**RE: Arboricultural Assessment of Supporting Removal of Tree 130 Sydney Red Gum:  
MP10\_0016 - "The Terraces" 2 Cooper Street, Paddington**

**Ref: 246MonTree130[AR-RE-P-1008]**

**Excerpt from Survey Ref: 10358, July 2006 by Clement & Reid.**

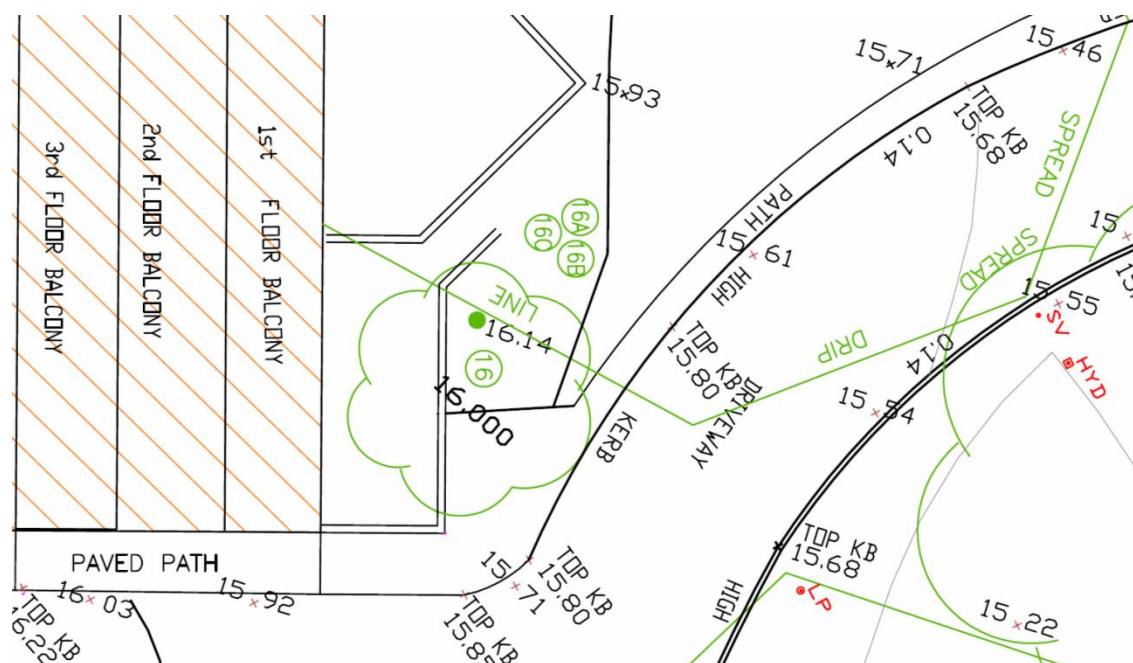
The assessment of the impact of the proposed building works on the tree in the Arboricultural Impact Assessment report for the DA (Ref: 246DAIA, September 2010) was in error. The close proximity of the trunk of the tree to the proposed Driveway ramp to the basement was not accurately assessed. The earlier tree number (#16) on the Survey was misinterpreted by some as the trunk of the tree. The actual trunk centre is at ERL 16.14 as indicated.

Excerpt from *Site Plan, DA101 Rev. P11* by JPRA.

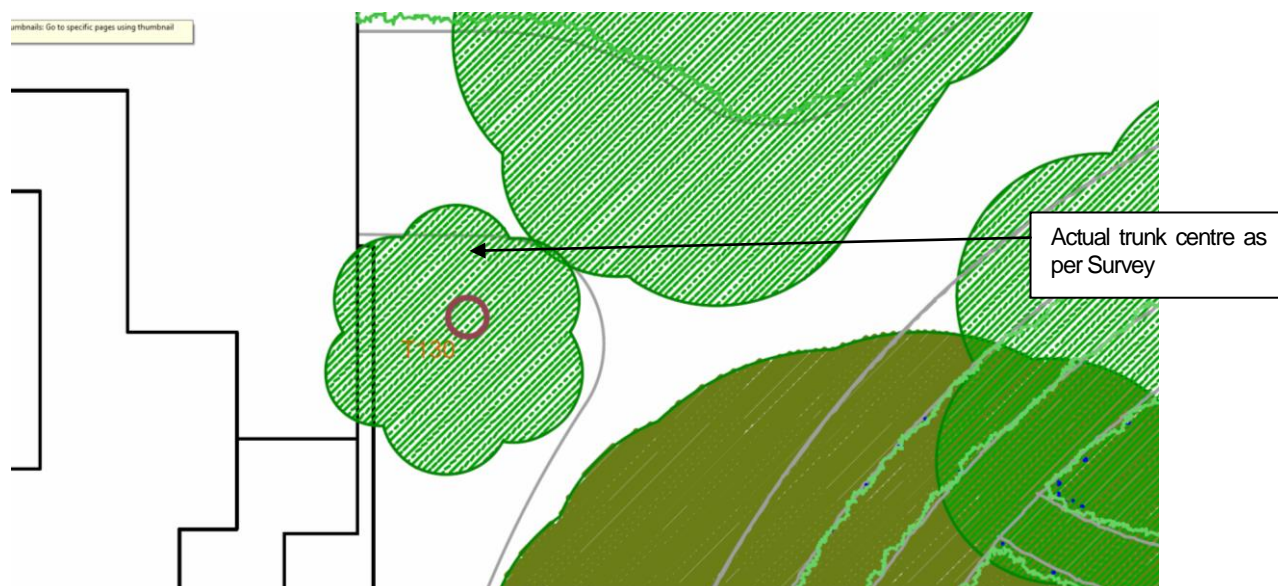
The JPRA Architectural set, Rev. P11, 7.09.10 reviewed for the AIA, September, 2010 had the trunk shown as the tree number rather than the trunk centre, marginally further from the proposed ramp than shown on the current Drawings.

Excerpt from *Level 01 Plan A-P-1103, Rev 10* by JPRA. Refer to Attachment C of detail of Sections 1 and 2.

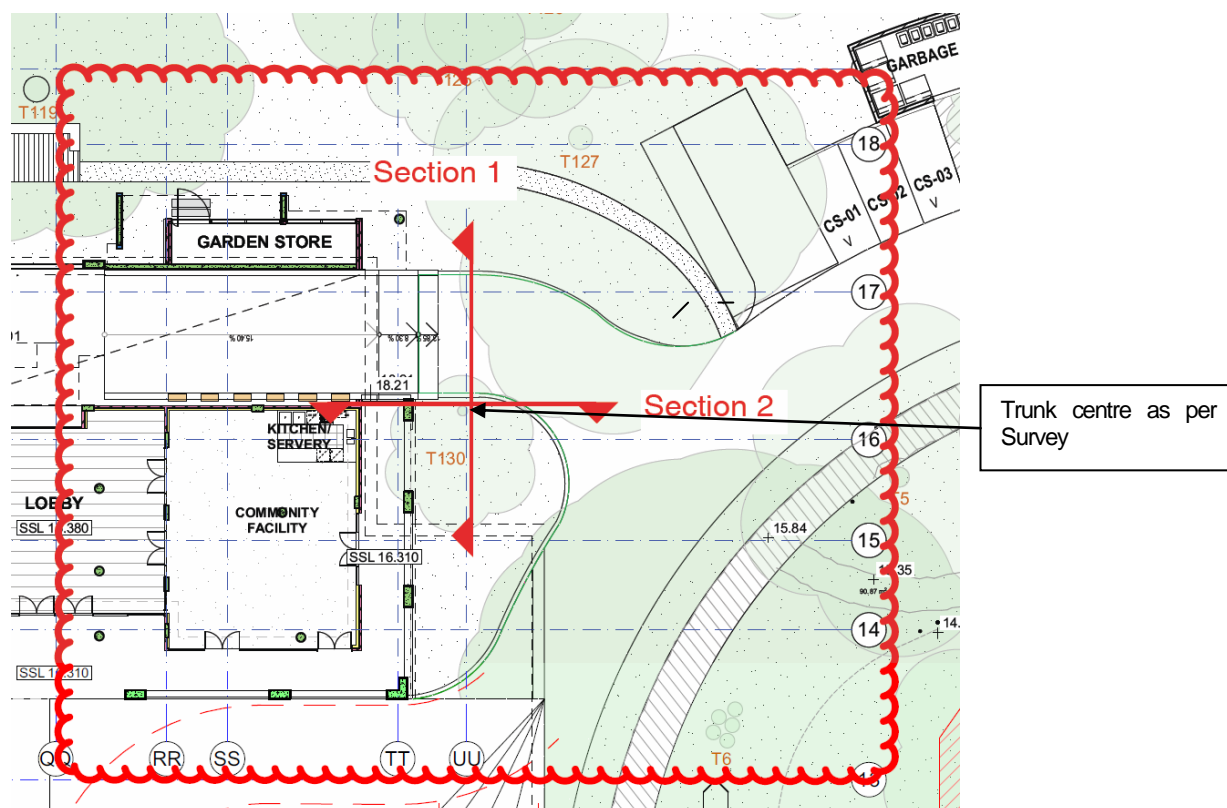
The current construction drawings show the actual trunk location well within the Structural Root Zone (SRZ) (2.8m) of the tree. In fact the excavation needed for the Driveway ramp down to the Basement is within 1m of the base of the tree and will result in root cutting on the tension side of the tree.
